# **Technical Memorandum**

TO: Mr. Alan Day, General Manager Brazos Valley Groundwater Conservation DistrictFROM: Christopher Drabek, P.G., and James Beach, P.G.

SUBJECT: Review of Trey Skiles Simsboro Aquifer Evaluation Report

**DATE:** March 6, 2023

Figure 2. GAM Simulated Drawdown Effects in Simsboro Aquifer After Proposed Skiles Pumping of 4,800 ac-ft/yr for 1-Year

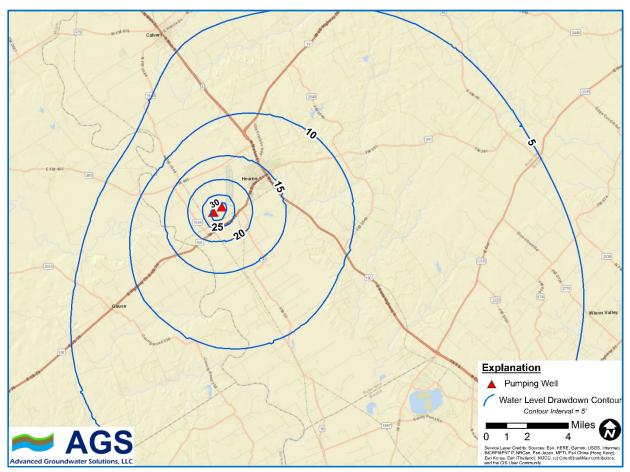
AGS simulated the requested annual permit allocation by assigning the proposed Trey Skiles well 2,100 ac-ft/yr of pumping at Node 162516 and BVDO-0108 2,700 ac-ft/yr of pumping at Node 162515. The AGS GAM simulation results after 1 and 10 years of pumping 4,800 ac-ft/yr show drawdown estimates that are generally about 5 feet or more greater than what is shown in the TGI simulation results. The AGS drawdown contours show that the estimated drawdown is spread over a larger geographical area than what is shown in the TGI report.

Figure 2 shows the AGS estimated effects that result from simulation of the requested 4,800 ac-ft of pumping from the Simsboro Aquifer after one year. AGS GAM simulated one year drawdown is estimated to range from about 22 to over 30 feet within one mile from the simulated Skiles wells and about 6 to 13 feet at a distance of five miles from the Skiles wells, depending on the direction from the proposed wells.

Figure 3. GAM Simulated Drawdown Effects in Simsboro Aquifer After Proposed Skiles Pumping of 4,800 ac-ft/yr for 10-Years

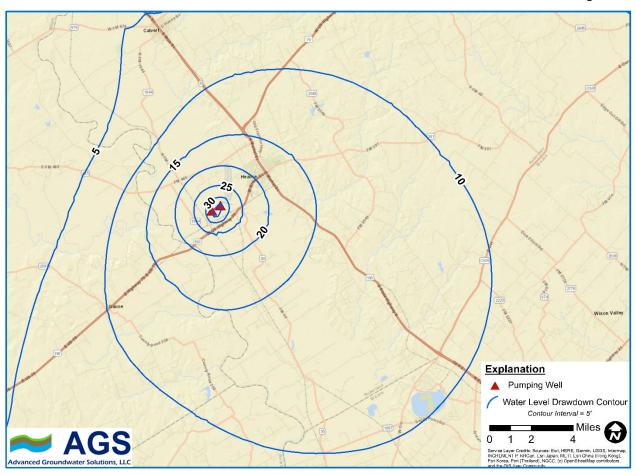
Figure 3 shows the AGS estimated effects that result from simulation of the requested 4,800 ac-ft of pumping from the Simsboro Aquifer after 10 years. AGS GAM simulated 10-year drawdown is estimated to be about 24 to over 35 feet within one mile from the simulated Trey Skiles wells and about 8 to 14 feet at a distance of five miles from the proposed and existing Trey Skiles wells, depending on the direction from the proposed wells.

The AGS GAM estimated 5-foot drawdown contours to the northwest appear to be influenced by a fault included in the GAM, which is in the same general area as a fault that has been mapped recently by Groundwater Consultants, LLC and AGS using local geophysical logs and other hydrogeologic data.

Figure 4. Analytical Simulated Drawdown Effects After Proposed Skiles Pumping of 4,800 ac-ft/yr for 1-Year

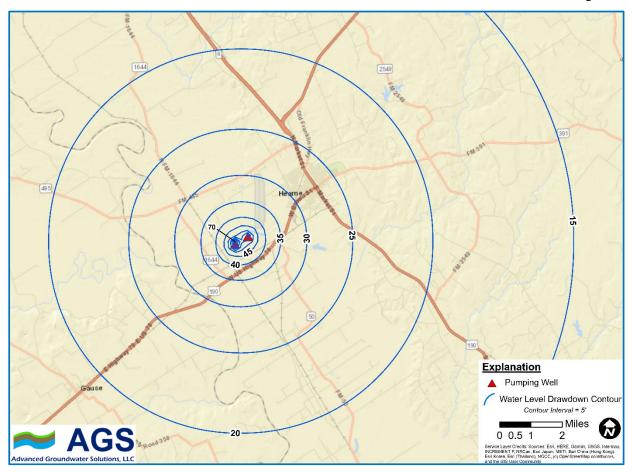
AGS estimated the drawdown at the pumping wells using the Theis analytical model and calculating the drawdown at one foot from the well. Using this approach, AGS simulated an additional 22 feet of drawdown at the proposed well location (1-year drawdown: 52 feet (TGI) versus 74 feet (AGS); 10-year drawdown: 62 feet (TGI) versus 84 feet (AGS)) and an additional 24 feet of drawdown at the existing BVDO-0108 location (1-year drawdown: 59 feet (TGI) versus 83 feet (AGS); 10-year drawdown: 70 feet (TGI) versus 94 feet (AGS)). AGS was able to verify the TGI analytical estimated drawdown at all other locations shown in Table 1 of the TGI report.

With this approach, there is an increased density of contours near the proposed Trey Skiles well and existing well BVDO-0108 and we think these are more appropriate estimates of "near well" drawdown. However, there are many factors that will determine the actual drawdown near the well during pumping, and therefore, these differences are assumed to be minor for the purposes of the AER. Figures 4 and 5 show the estimated AGS analytical modeling drawdown contours that result from pumping 4,800 ac-ft/yr for 1-year and 10-years, respectively. Simulated drawdown contours at distance are similar for both methodologies.

Figure 6. Projected GMA 12 2021 Planning Cycle DFC Water Level Decline at the Proposed Trey Skiles Well and Existing Well BVDO-0108

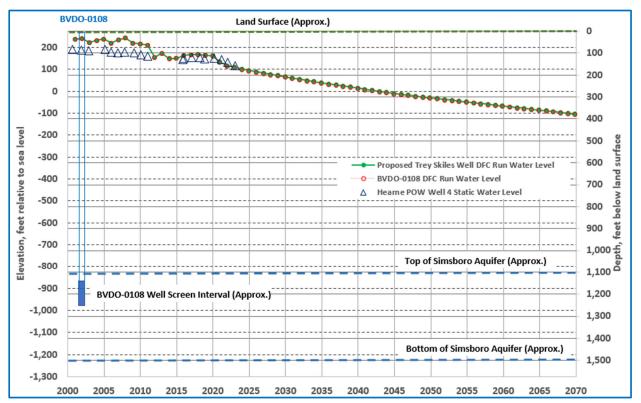
As a way of evaluating potential long-term estimated water level decline at the proposed Trey Skiles well and existing well BVDO-0108, AGS plotted the simulated water level decline at each well location based on the 2021 GMA 12 DFC/Modeled Available Groundwater (MAG) projections for the Simsboro Aquifer as shown in Figure 6 below. The water level projections shown in Figure 6 are from the TWDB approved DFC/MAG run known as GMA 12 "S-19", but do not include the local impacts from the proposed Trey Skiles well and the requested well BVDO-0108 permitted production increase included in the AER, nor do they include all of the pumping from the Simsboro Aquifer that has been permitted in the area in the past year. The DFC run includes pumping estimates from the Groundwater Conservation Districts in GMA 12 as of about December 2021 that yield DFCs so that the TWDB can estimate the MAG. The detailed assumptions for the DFC simulation can be found in the GMA 12 Explanatory Report (Daniel B. Stephens & Associates and others, 2022) and documentation of the TWDB MAG run can be found in GAM Run 21-017 MAG: Modeled Available Groundwater for the Aquifers in Groundwater Management Area 12 (Shi and Harding, 2022).

The graph illustrates the relationship between the land surface, estimated static water level through time, and the estimated top and bottom of the Simsboro Aquifer at the location of the proposed Trey Skiles well and BVDO-0108. Select historical static water level measurements are also shown on Figure 6 for the City of Hearne POW Well 4 (BVGCD Permit BVHU-0013), which is located about 2.1 miles to the north-northeast of the proposed Trey Skiles well and screen sands of the Simsboro Aquifer in the depth interval of about 1,221 to 1,426 feet below land surface or approximately -920 to -1,133 feet rsl).

Available drawdown in wells in the Simsboro Aquifer will decline over time based on the DFC simulation. Pumping water levels in wells in areas of concentrated pumping could be one hundred or more feet deeper than the estimated regional static water levels shown on Figure 6. Although not evaluated or discussed in detail herein, these levels of water level decline in wells and artesian head decline in the aquifer will have some impact on vertical leakage, intercepted discharge, reduction in confined and unconfined storage, and potential flow directions in the aquifer.
